**CITY OF SAINT PAUL
HERITAGE PRESERVATION COMMISSION STAFF REPORT**

FILE NAME: 201-209 Fourth Street East
HISTORIC NAME: Wann Building
DATE OF APPLICATION: April 1, 2020
APPLICANT: Mike Sowers, Commercial Construction Group
OWNER: Commercial Construction Group
PROJECT ARCHITECT: Dan Pollastrini, Pope Architects
DATE OF HPC MEETING: April 20, 2020
HPC SITE/DISTRICT: Historic Lowertown Heritage Preservation District (1984) - RA-SPC-4580
CATEGORY: Contributing
INVENTORY NUMBER: RA-SPC-5224
PERIOD OF SIGNIFICANCE: 1867-1929
NRHP: Lowertown Historic District (1983)
NPS PROJECT NO: 39564
CLASSIFICATION: Master Sign Plan
ZONING: B5 **WARD:**2 **PLANNING DISTRICT:** 17
STAFF INVESTIGATION AND REPORT: Christine Boulware
DATE: April 8, 2020

Wann Building, 201 E. Fourth Street; St. Paul, Minnesota—NPS Project #39564

Figs. 12 & 13. Corner of Wann Building before the 1926 exterior face (at left) and Wann Building in ca. 1926 with multiple signs (above and below sign band) and on roof.

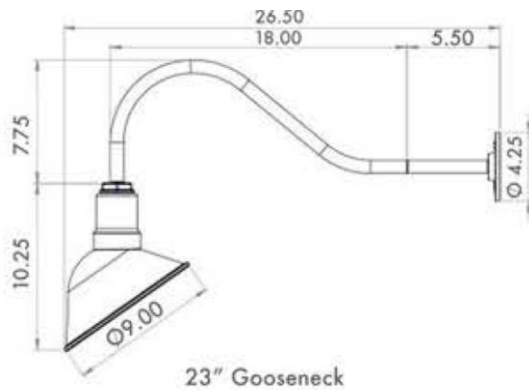
Describe existing feature and its condition: Signage at this building is a mix of plastic panels and awnings. Historic signage does not exist at this building. Historic images reflect a range of signage types through the years. (See historic images-Figs. 12 & 13)

Informal SHPO comments on signage recommended the following: *“New hanging signs may be appropriate for historic commercial buildings, if they are of a scale and design compatible with the historic buildings. Please provide documentation that illustrates there were blade signs spanning multiple floors mounted to the building at the two locations indicated — within the period of significance. A smaller blade sign at the primary corner appears to be appropriate and there is historic precedent for this location...Surface mounted signage at the face of the building, on the upper floor pilasters, will not meet the Standards. A great place to locate new signage is in the historic signboard area of the storefronts. Signs should be of a size and style compatible with the historic building and should not cover or obscure significant architectural detailing or features.”*

SIGN 1

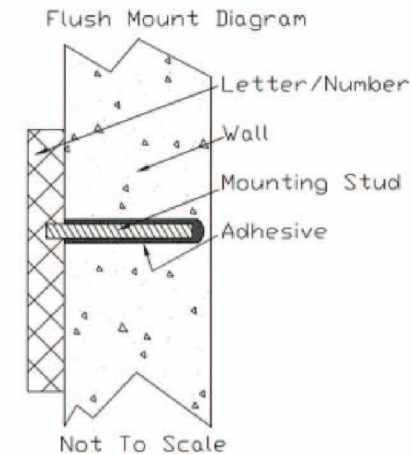
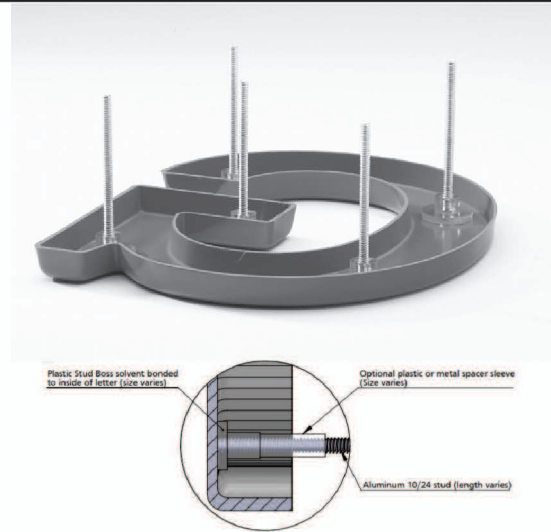
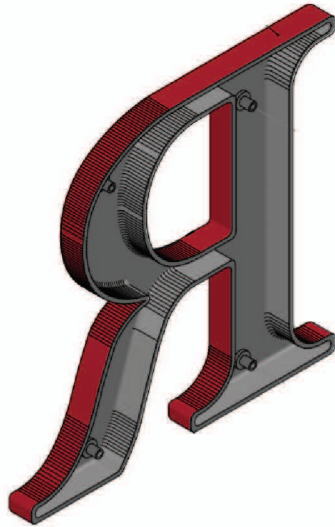
- ~~1" deep formed plastic~~ 1/2" thick laser cut metal
- Font: Futura Condensed
- Color: Duranodic Bronze
- Stud mounted into grout lines

GENERIC EXAMPLE OF RAILWAY MOUNTED SIGNAGE

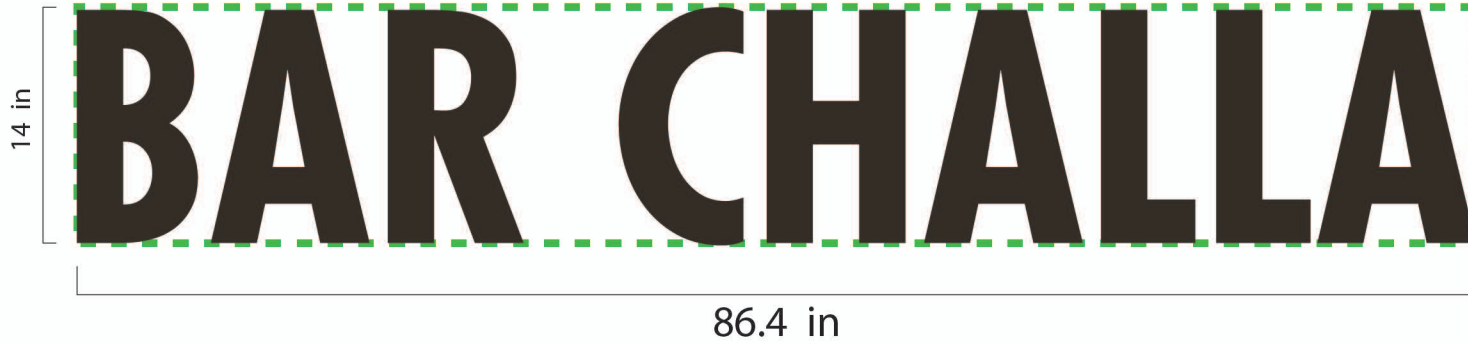
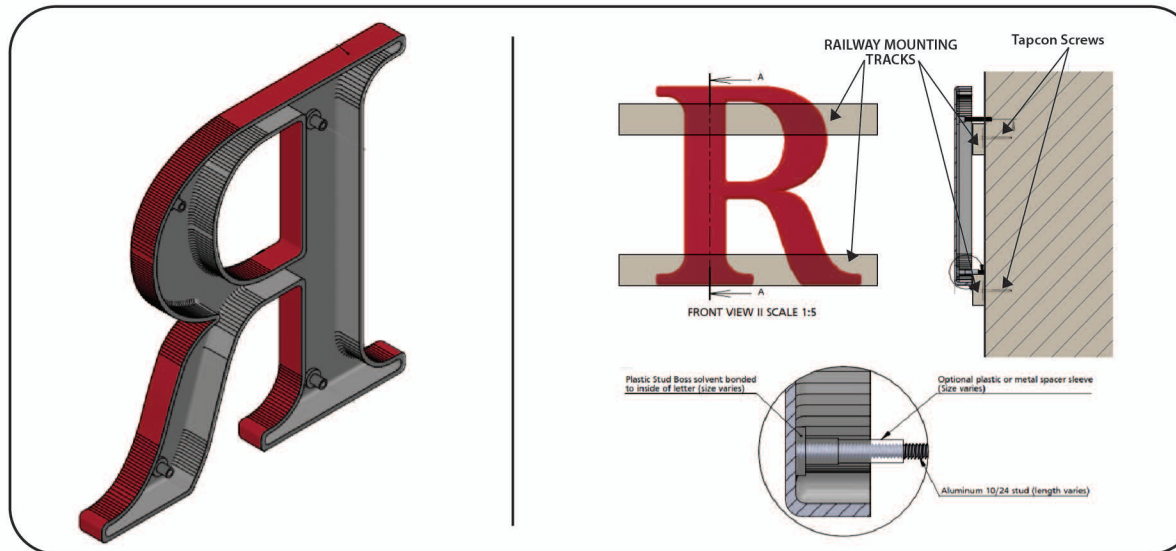
- ~~1" deep formed plastic~~
- Color: Duranodic Bronze
- Mounted with railway tracks
